**TOWN OF NEWBURGH
PLANNING BOARD
TECHNICAL REVIEW COMMENTS**

PROJECT NAME: POSITIVE DEVELOPERS WAREHOUSE
PROJECT NO.: 22-16
PROJECT LOCATION: 36 RAQUET ROAD
SECTION 86, BLOCK 1, LOT 26.31
REVIEW DATE: 13 JANUARY 2023
MEETING DATE: 19 JANUARY 2023
PROJECT REPRESENTATIVE: ENGINEERING AND SURVEYING PROPERTIES, PC

Proposed Warehouse – 36 Racquet Road
Town of Newburgh, Orange County, New York
Colliers Engineering & Design Project No. 22009749A

**RE: W.O. # 1746.02 (PB #22-16)
POSITIVE DEVELOPERS WAREHOUSE
SITE PLAN APPLICATION (86-1-26.31)
RESPONSE LETTER**

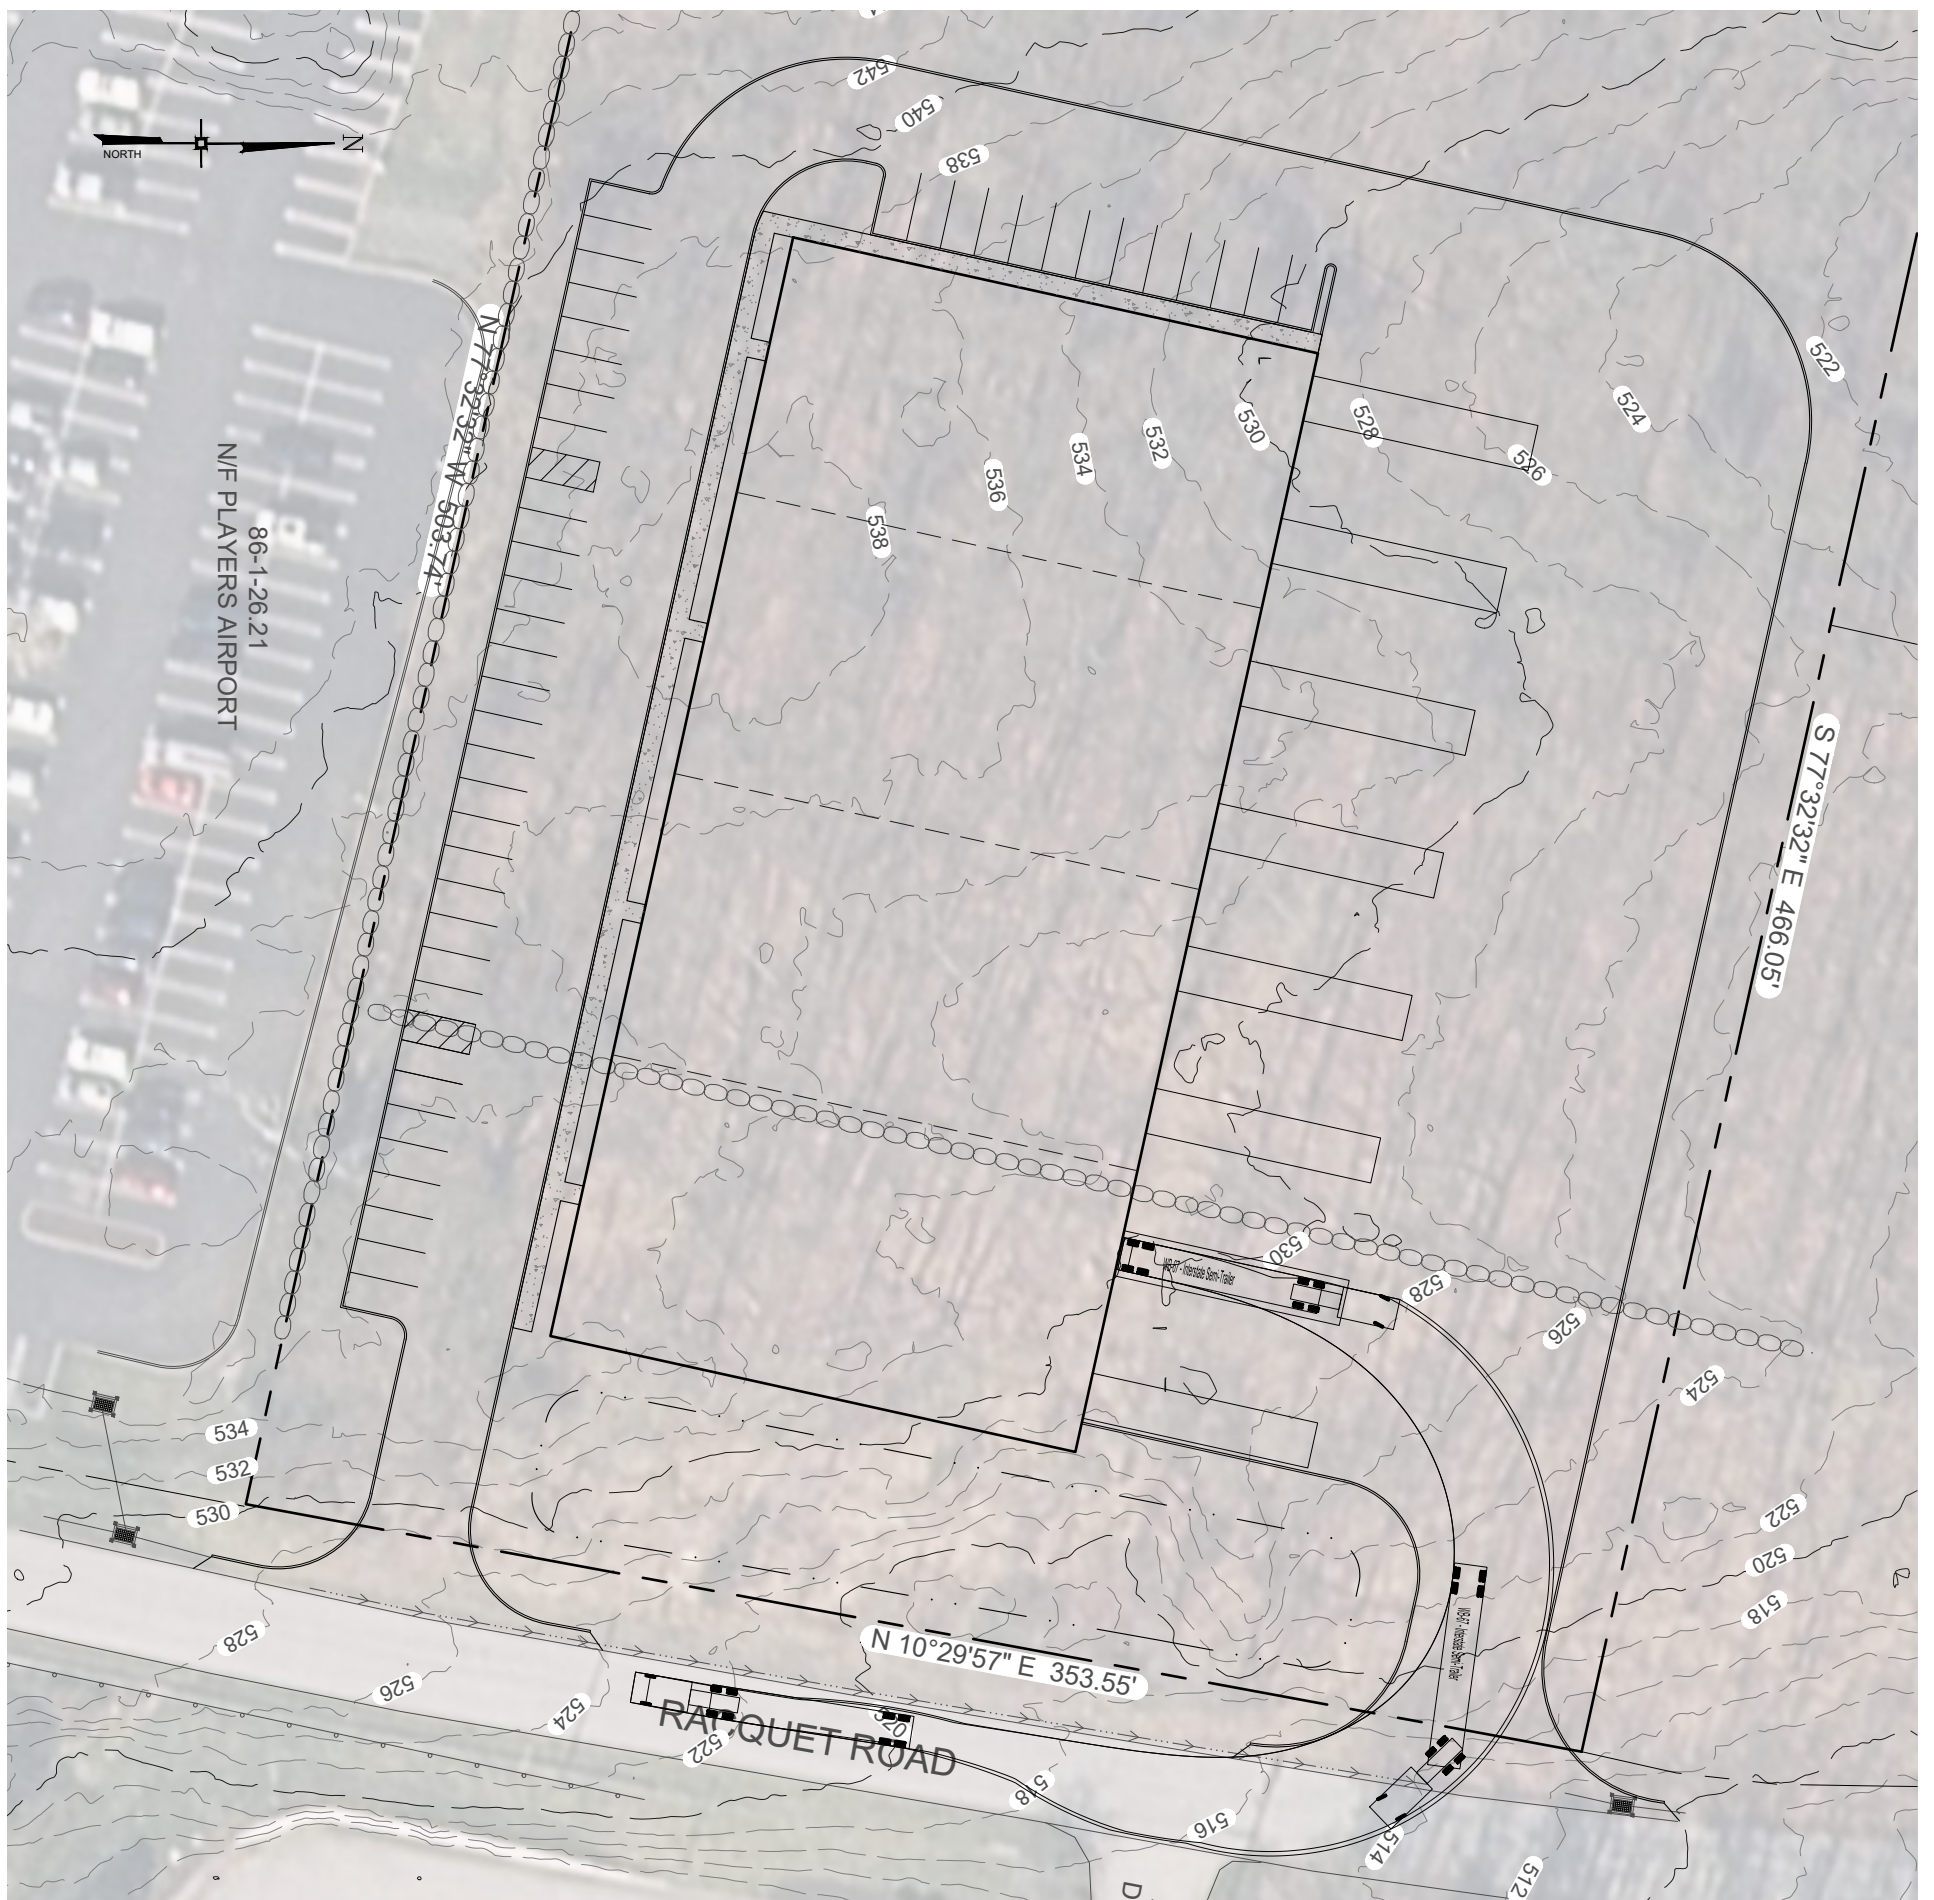
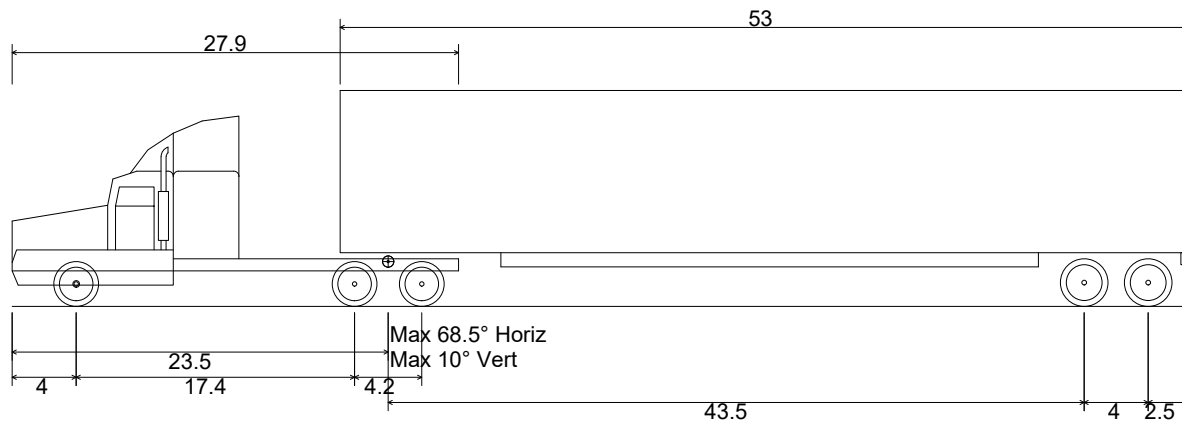
1. Truck turning movements are based on a WB-62 truck (48-foot trailer), which is the next size smaller than the typical interstate truck (WB-67, 53-foot trailer). For a WB-62, access appears reasonable into and out of the site onto Racquet Road. Some small changes to the truck entrance would likely accommodate the larger 53-foot trailers. Unless a known tenant will only be using 48-foot trailers, the site should be designed for the potential use of 53-foot trailers.

Response: Truck turning diagrams for the WB-67 are now shown for the access intersections as well as NYS Route 17K.

TRUCK ENTERING FIGURE RACQUET ROAD	POSITIVE DEVELOPERS WAREHOUSE 36 RACQUET ROAD TOWN OF NEWBURGH ORANGE COUNTY, NEW YORK	DATE: 12/22/2022	JOB # 1746.02		MONTGOMERY OFFICE 71 CLINTON STREET MONTGOMERY, NY 12549 Ph: (845) 457-7727 WWW.EP-PC.COM
		SCALE: 1" = 50'	SHEET # F-3

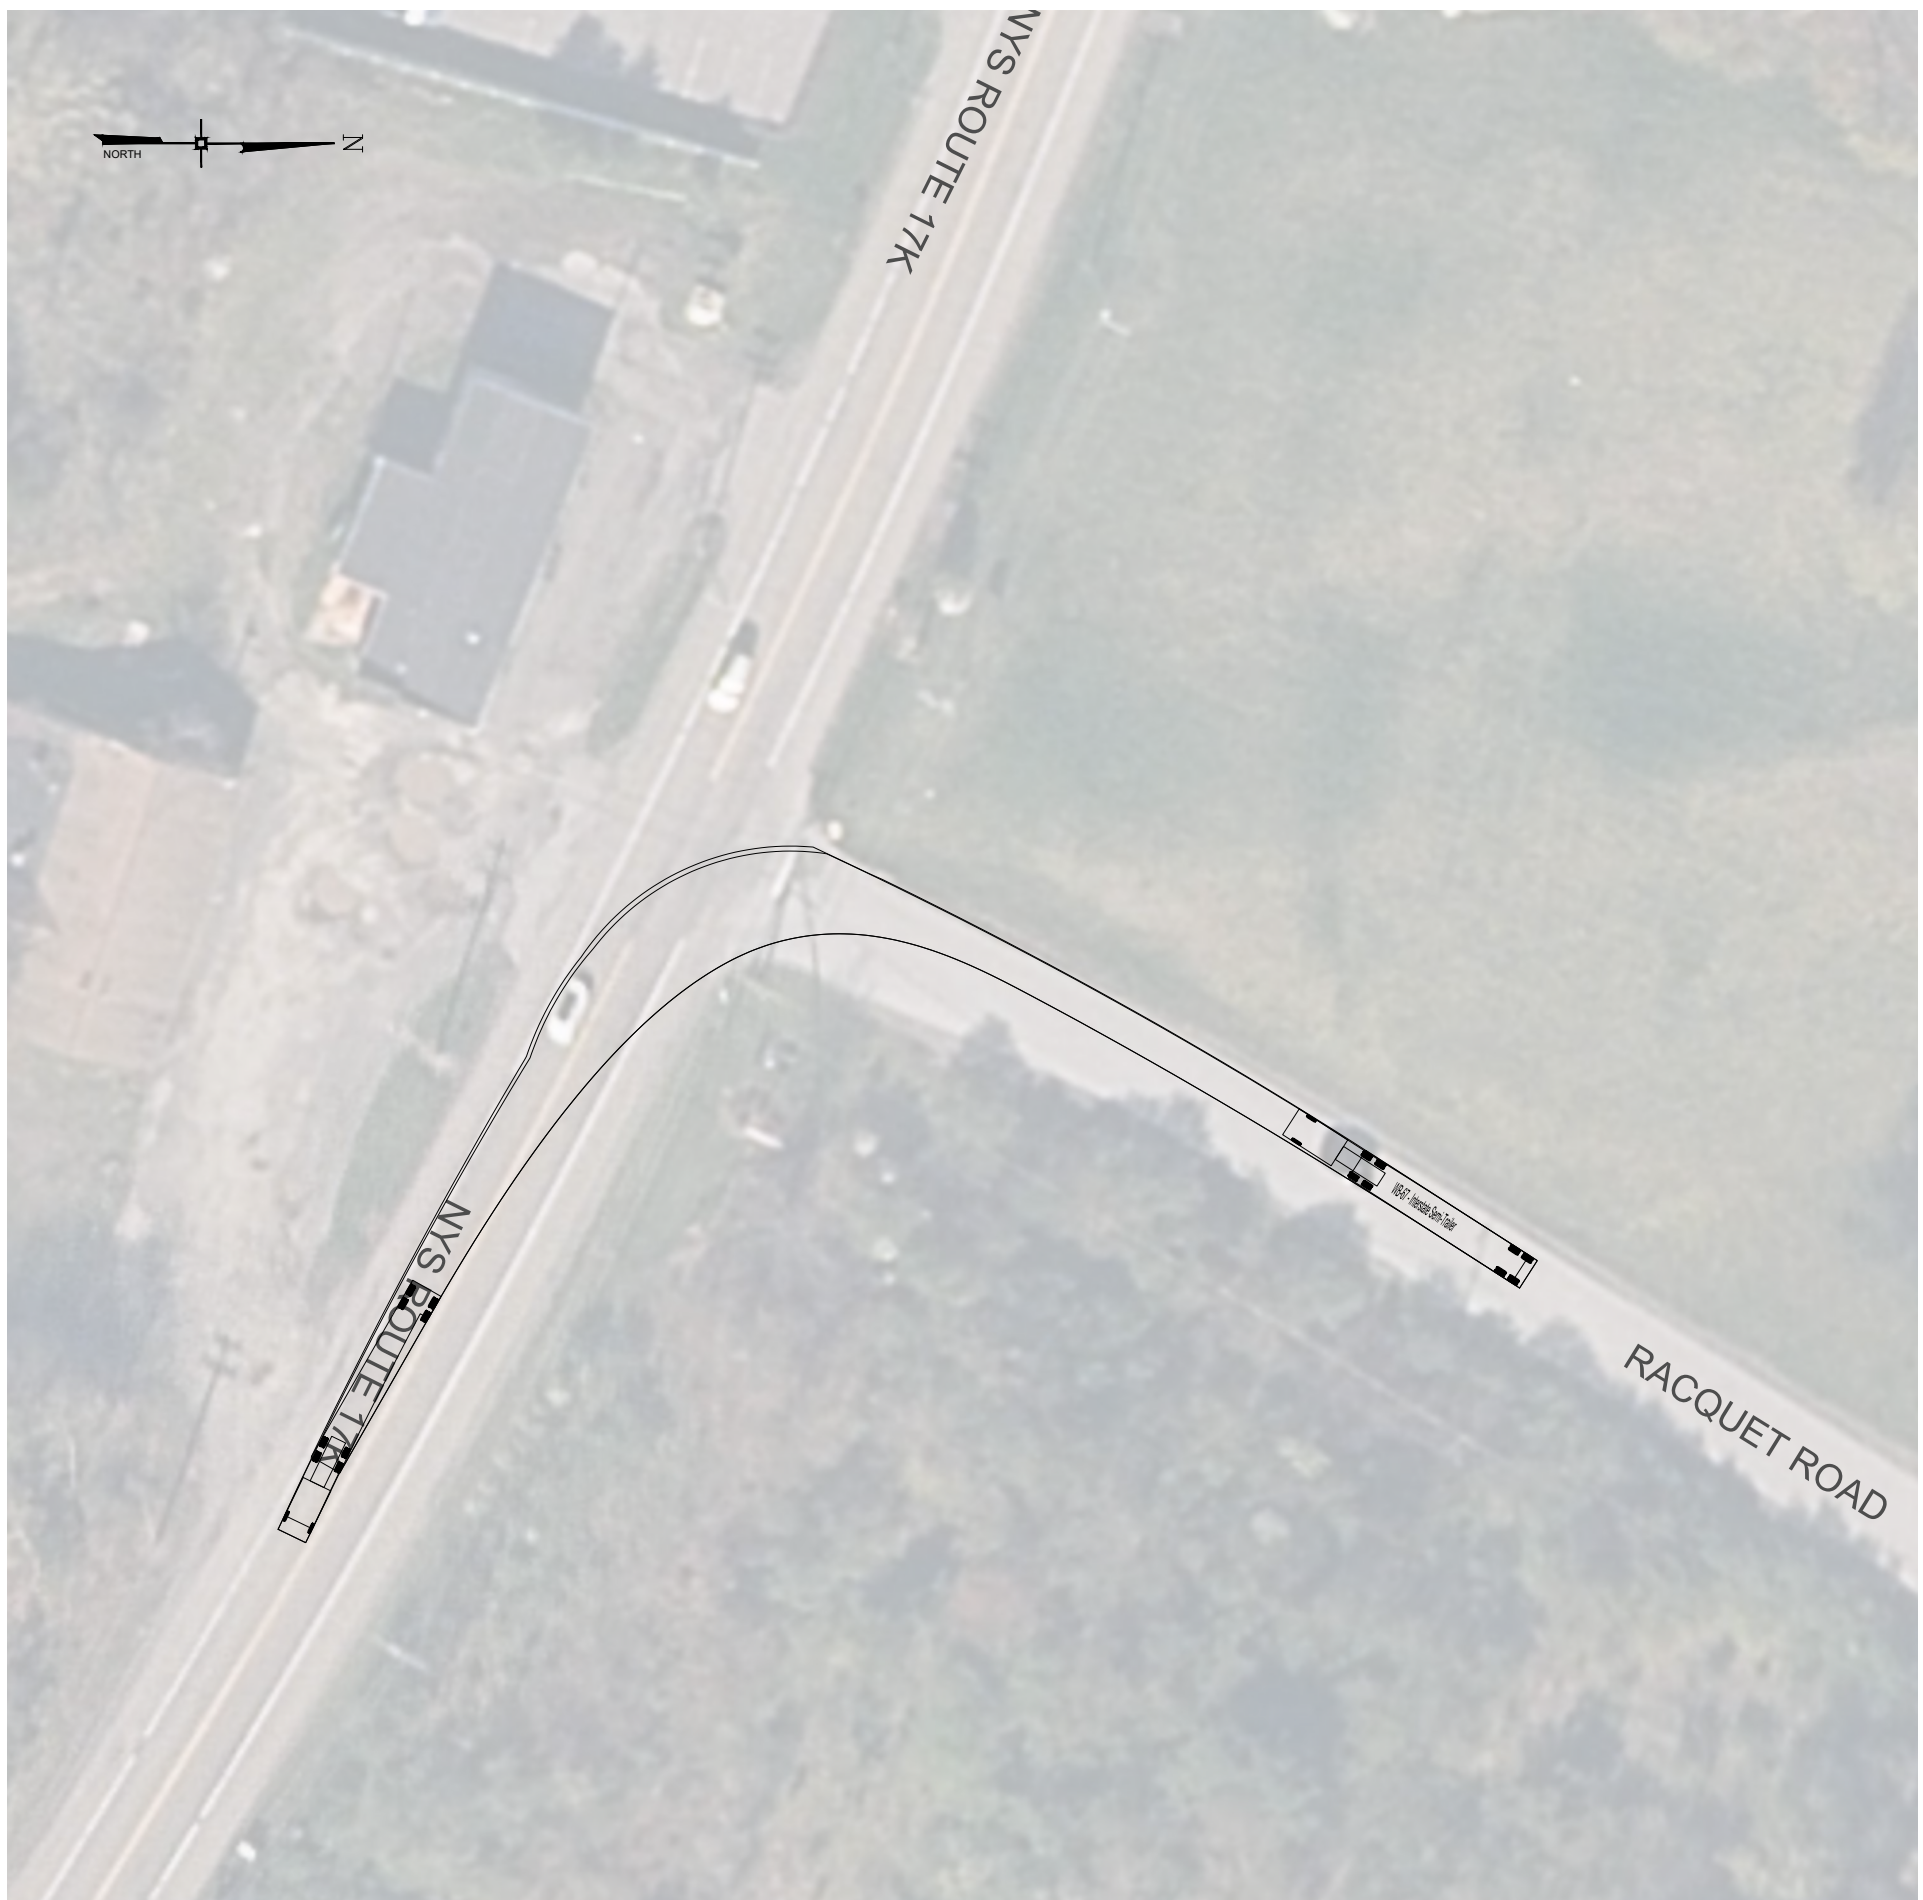
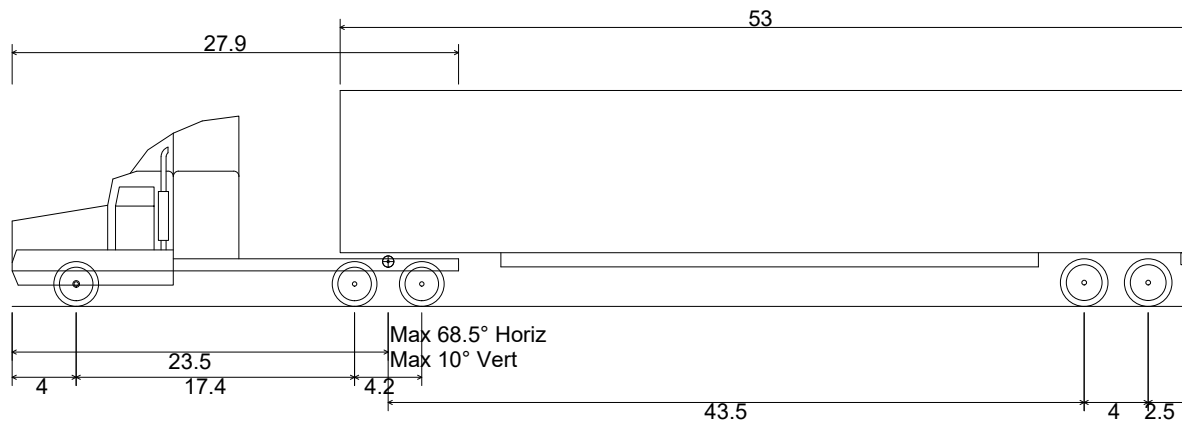
2. Truck access to/from Route 17K will be a challenge, namely for any trucks turning left and right onto Racquet Road from Route 17K. Trucks turning into Racquet Road will require no traffic trying to exit Racquet Road on the southbound approach. The right turn movement, as demonstrated in the truck template, would require a truck to cross into oncoming lanes on Route 17K and Racquet Road. As such, widening the radii at the intersection is likely needed. Widening Route 17K with a center turn lane may also help.

Response: Comment noted. See updated truck turning templates.
